Access Compliance Report

Public Rights-of-Way

(Curb Ramps)

Intersection ID: 27985	Main Street: FAIR_ISLE_DR	Cross Street: PROVIDENCE_RD_WEST	Location: NW
ADA ID: 2C2D023368B5	Ramp Type: Perp	Initial Pass/Fail: Fail	Overall Compliance: No
		Severity Score: 12.5

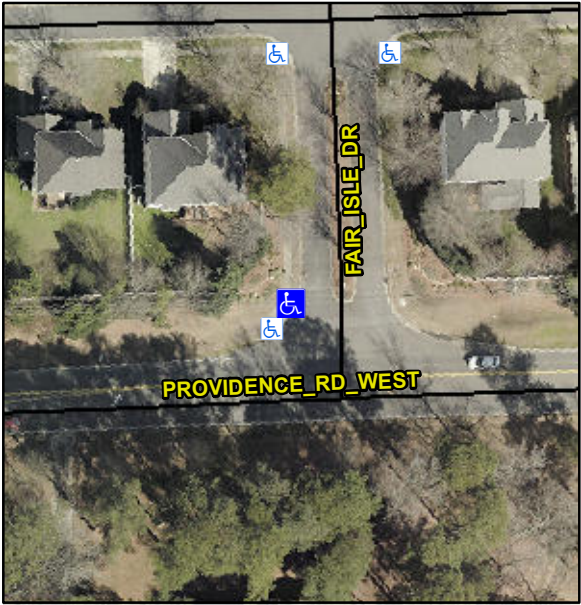
Codes/Mitigation Info/Possible Solution			Field Measurements/Component Compliance		
	Possible Solutions:		Compliance	Description	Data
	Remove & Replace Entire Ramp.		No	Ramp Length (in)	97.0
			Yes	Ramp Width (in)	48.0
			N/A	Flare Type LT	N/A
			N/A	Flare Slope LT (%)	N/A
			N/A	Flare Traversable LT?	N/A
			N/A	Landing Length (in)	N/A
			N/A	Landing Width (in)	N/A
			N/A	Landing Slope (%)	N/A
			N/A	Landing X Slope (%)	N/A
<p>Surveyor Notes:</p> <p>N/A</p> <p>PROW/ADA:</p> <p>Not Found, R304.2.2</p>			N/A	Flare Type RT	N/A
			N/A	Flare Slope RT (%)	N/A
			N/A	Flare Traversable RT?	N/A
			N/A	DWS Provided?	N/A
			N/A	DWS Contrast?	N/A
			N/A	DWS Length (in)	N/A
			N/A	DWS Full Width?	N/A
			N/A	DWS Offset (in)	N/A
			N/A	Gutter Ponding?	N/A
			N/A	Gutter Lip Ht (in)	N/A
<p>Total Cost:</p> <p>\$ 1850.00</p>			No	Painted X Walk1?	N/A
			To E	X Walk 2 Direction	N/A
			N/A	X Walk 2 Width (in)	N/A

1.4	X Walk 2 Slope (%)	N/A
			1.8	X Walk 2 X Slope (%)	N/A
			N/A	Ramp inside XWalk1?	N/A
			N/A	Ramp inside XWalk2?	N/A
			N/A	Clear Space?	N/A
			N/A	Clear Space to XWalk (in)	N/A
			N/A	Storm Grate/Utility Hazard?	N/A
<p>Obstruction Type</p> <p>N/A</p>			N/A	Storm Grate/Utility Type	N/A
			N/A	Surface Condition? (G/P)	Good
